2021年度第1四半期安全実績指標PIデータの修正前後表 (1/2)

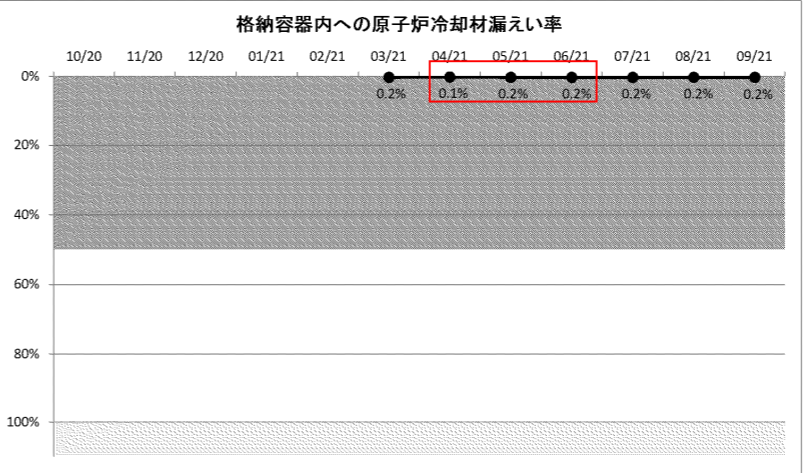
変更前	変更後	変更理由																																																																																																																																																		
<p style="text-align: center;">2021年度第1四半期 安全実績指標(PI) 関西電力株式会社 高浜発電所 3号機</p> <p>格納容器内への原子炉冷却材漏えい率</p> <table border="1" data-bbox="201 535 1216 625"> <thead> <tr> <th></th> <th>07/20</th> <th>08/20</th> <th>09/20</th> <th>10/20</th> <th>11/20</th> <th>12/20</th> <th>01/21</th> <th>02/21</th> <th>03/21</th> <th>04/21</th> <th>05/21</th> <th>06/21</th> </tr> </thead> <tbody> <tr> <td>格納容器内への原子炉冷却材漏えい率</td> <td>-</td> <td>-</td> <td>-</td> <td>-</td> <td>-</td> <td>-</td> <td>-</td> <td>-</td> <td>0.003</td> <td>0</td> <td>0</td> <td>0</td> </tr> <tr> <td>保安規定に定める運転上の制限値</td> <td>2.3</td> <td>2.3</td> <td>2.3</td> <td>2.3</td> <td>2.3</td> <td>2.3</td> <td>2.3</td> <td>2.3</td> <td>2.3</td> <td>2.3</td> <td>2.3</td> <td>2.3</td> </tr> <tr> <td>PI値</td> <td>#N/A</td> <td>#N/A</td> <td>#N/A</td> <td>#N/A</td> <td>#N/A</td> <td>#N/A</td> <td>#N/A</td> <td>#N/A</td> <td>0.2%</td> <td>0.0%</td> <td>0.0%</td> <td>0.0%</td> </tr> <tr> <td>評価</td> <td>#N/A</td> <td>#N/A</td> <td>#N/A</td> <td>#N/A</td> <td>#N/A</td> <td>#N/A</td> <td>#N/A</td> <td>#N/A</td> <td>緑</td> <td>緑</td> <td>緑</td> <td>緑</td> </tr> </tbody> </table> <p>しきい値</p> <table border="1" data-bbox="201 640 409 709"> <tbody> <tr> <td>緑</td> <td>0~50.0%</td> </tr> <tr> <td>白</td> <td>>50.0%</td> </tr> <tr> <td>黄</td> <td>>100.0%</td> </tr> <tr> <td>赤</td> <td>設定なし</td> </tr> </tbody> </table> 		07/20	08/20	09/20	10/20	11/20	12/20	01/21	02/21	03/21	04/21	05/21	06/21	格納容器内への原子炉冷却材漏えい率	-	-	-	-	-	-	-	-	0.003	0	0	0	保安規定に定める運転上の制限値	2.3	2.3	2.3	2.3	2.3	2.3	2.3	2.3	2.3	2.3	2.3	2.3	PI値	#N/A	#N/A	#N/A	#N/A	#N/A	#N/A	#N/A	#N/A	0.2%	0.0%	0.0%	0.0%	評価	#N/A	#N/A	#N/A	#N/A	#N/A	#N/A	#N/A	#N/A	緑	緑	緑	緑	緑	0~50.0%	白	>50.0%	黄	>100.0%	赤	設定なし	<p style="text-align: center;">2021年度第2四半期 安全実績指標(PI) 関西電力株式会社 高浜発電所 3号機</p> <p>格納容器内への原子炉冷却材漏えい率</p> <table border="1" data-bbox="1380 520 2389 611"> <thead> <tr> <th></th> <th>10/20</th> <th>11/20</th> <th>12/20</th> <th>01/21</th> <th>02/21</th> <th>03/21</th> <th>04/21</th> <th>05/21</th> <th>06/21</th> <th>07/21</th> <th>08/21</th> <th>09/21</th> </tr> </thead> <tbody> <tr> <td>格納容器内への原子炉冷却材漏えい率</td> <td>-</td> <td>-</td> <td>-</td> <td>-</td> <td>-</td> <td>0.003</td> <td>0.002</td> <td>0.003</td> <td>0.003</td> <td>0.003</td> <td>0.003</td> <td>0.004</td> </tr> <tr> <td>保安規定に定める運転上の制限値</td> <td>2.3</td> <td>2.3</td> <td>2.3</td> <td>2.3</td> <td>2.3</td> <td>2.3</td> <td>2.3</td> <td>2.3</td> <td>2.3</td> <td>2.3</td> <td>2.3</td> <td>2.3</td> </tr> <tr> <td>PI値</td> <td>#N/A</td> <td>#N/A</td> <td>#N/A</td> <td>#N/A</td> <td>#N/A</td> <td>0.2%</td> <td>0.1%</td> <td>0.2%</td> <td>0.2%</td> <td>0.2%</td> <td>0.2%</td> <td>0.2%</td> </tr> <tr> <td>評価</td> <td>#N/A</td> <td>#N/A</td> <td>#N/A</td> <td>#N/A</td> <td>#N/A</td> <td>緑</td> <td>緑</td> <td>緑</td> <td>緑</td> <td>緑</td> <td>緑</td> <td>緑</td> </tr> </tbody> </table> <p>しきい値</p> <table border="1" data-bbox="1380 625 1587 695"> <tbody> <tr> <td>緑</td> <td>0~50.0%</td> </tr> <tr> <td>白</td> <td>>50.0%</td> </tr> <tr> <td>黄</td> <td>>100.0%</td> </tr> <tr> <td>赤</td> <td>設定なし</td> </tr> </tbody> </table> 		10/20	11/20	12/20	01/21	02/21	03/21	04/21	05/21	06/21	07/21	08/21	09/21	格納容器内への原子炉冷却材漏えい率	-	-	-	-	-	0.003	0.002	0.003	0.003	0.003	0.003	0.004	保安規定に定める運転上の制限値	2.3	2.3	2.3	2.3	2.3	2.3	2.3	2.3	2.3	2.3	2.3	2.3	PI値	#N/A	#N/A	#N/A	#N/A	#N/A	0.2%	0.1%	0.2%	0.2%	0.2%	0.2%	0.2%	評価	#N/A	#N/A	#N/A	#N/A	#N/A	緑	緑	緑	緑	緑	緑	緑	緑	0~50.0%	白	>50.0%	黄	>100.0%	赤	設定なし	<p>格納容器内への原子炉冷却材漏えい率について、データを修正。 (入力データの誤り)</p>

緑	0~50.0%																																																																																																																																																			
白	>50.0%																																																																																																																																																			
黄	>100.0%																																																																																																																																																			
赤	設定なし																																																																																																																																																			
	10/20	11/20	12/20	01/21	02/21	03/21	04/21	05/21	06/21	07/21	08/21	09/21																																																																																																																																								
格納容器内への原子炉冷却材漏えい率	-	-	-	-	-	0.003	0.002	0.003	0.003	0.003	0.003	0.004

保安規定に定める運転上の制限値	2.3	2.3	2.3	2.3	2.3	2.3	2.3	2.3	2.3	2.3	2.3	2.3																																																																																																																																								
PI値	#N/A	#N/A	#N/A	#N/A	#N/A	0.2%	0.1%	0.2%	0.2%	0.2%	0.2%	0.2%																																																																																																																																								
評価	#N/A	#N/A	#N/A	#N/A	#N/A	緑	緑	緑	緑	緑	緑	緑																																																																																																																																								
緑	0~50.0%																																																																																																																																																			
白	>50.0%																																																																																																																																																			
黄	>100.0%
